# Access Compliance Report

## Public Rights-of-Way

### (Curb Ramps)

Intersection ID: 15287	Main Street: ALBEMARLE_RD	Cross Street: N_SHARON_AMITY_RD	Location: SW
ADA ID: 99B73E38F595	Ramp Type: Para	Initial Pass/Fail: Fail	Overall Compliance: No
			Severity Score: 13.75

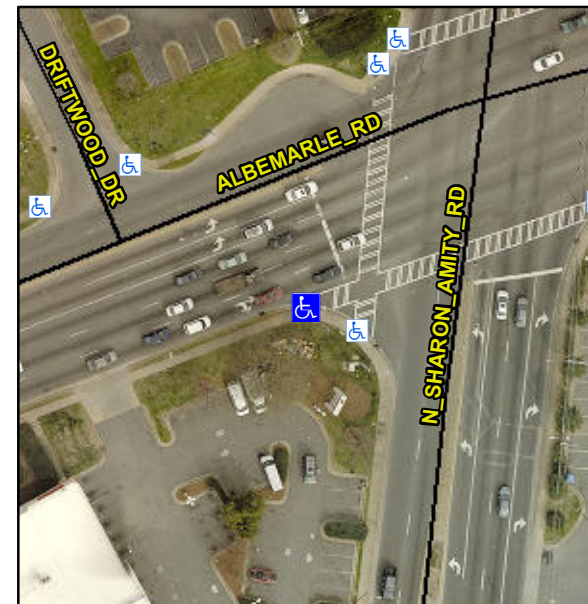
**RT RP < 5%**

**R304.3.2, R304.5.3**

**Remove & Replace Entire Ramp.**
